**Amendments to the Drawings:**

Attachment: Replacement Sheet

Fig. 1

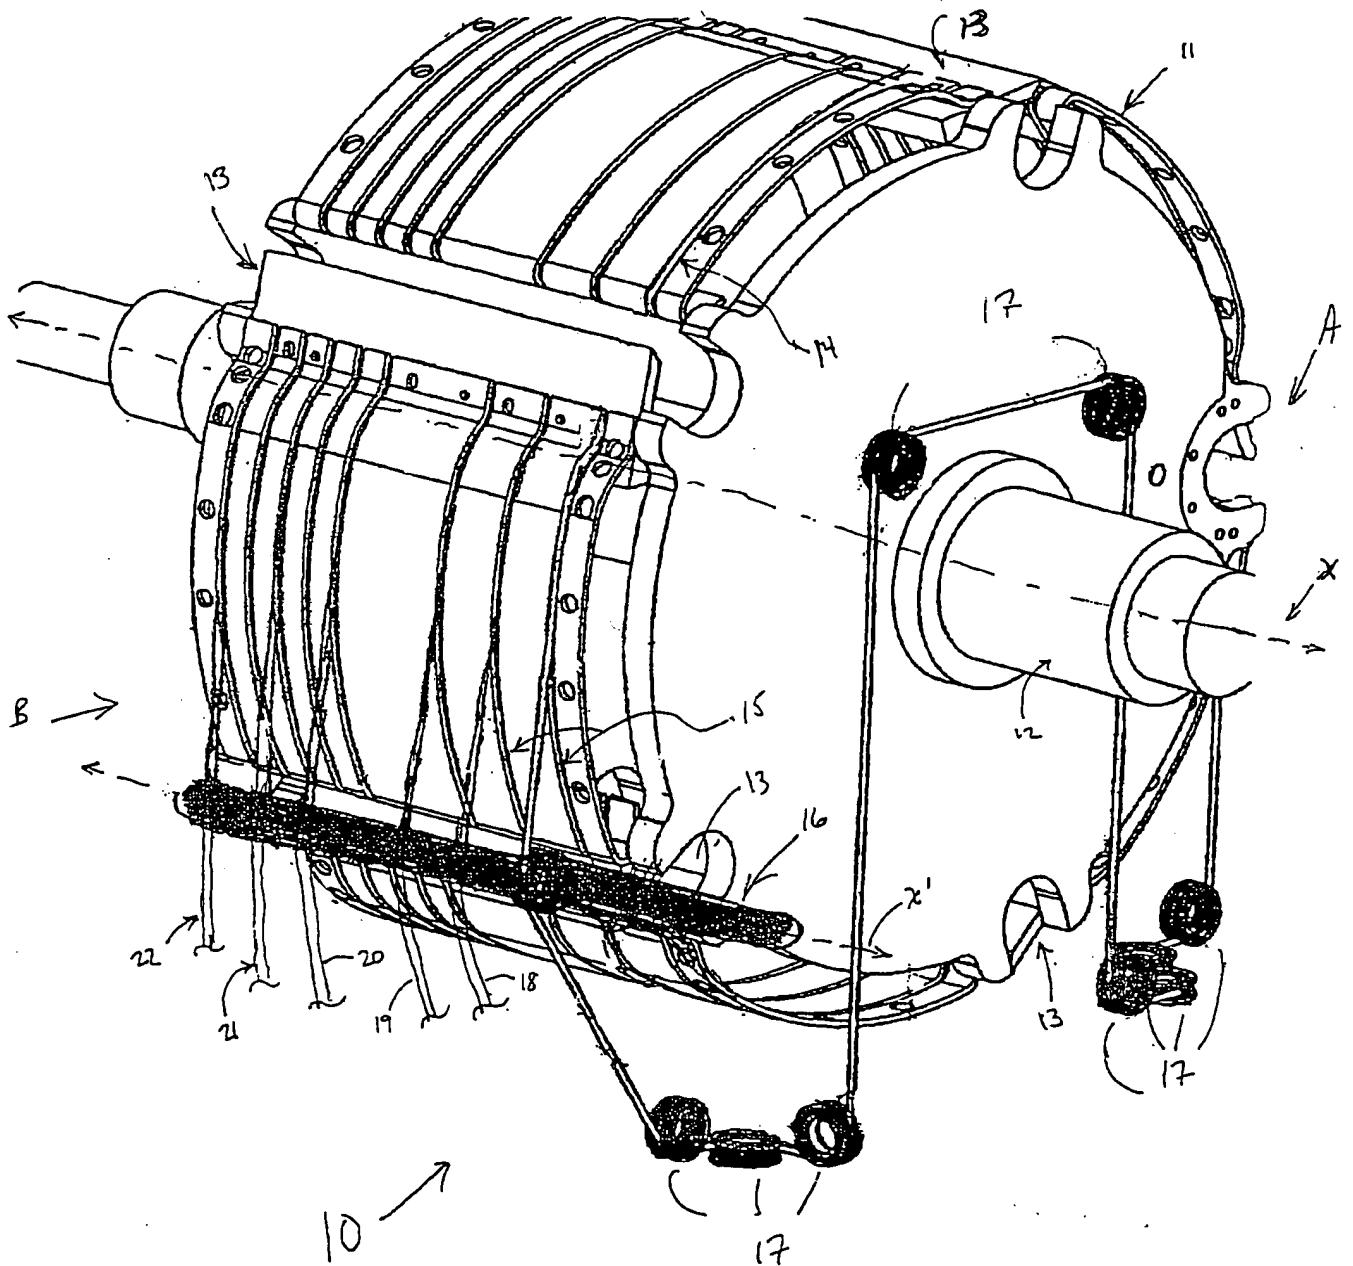
The attached sheet of drawings includes changes to Fig. 1. The attached sheet replaces the original sheet including Fig. 1. In Fig. 1, portions of the stripper belt in the regions of grippers 13 have been deleted to indicate that the path of the stripper belt passes beneath the grippers 13. In addition, previously omitted reference numbers 18-22, pointing to additional stripper belts, have been added. Finally, the stripper belts 18-22 have been extended beyond stripper roller 16 so as to more clearly indicate that only a portion of the additional stripper belts 18-22 is being shown in Fig. 1.
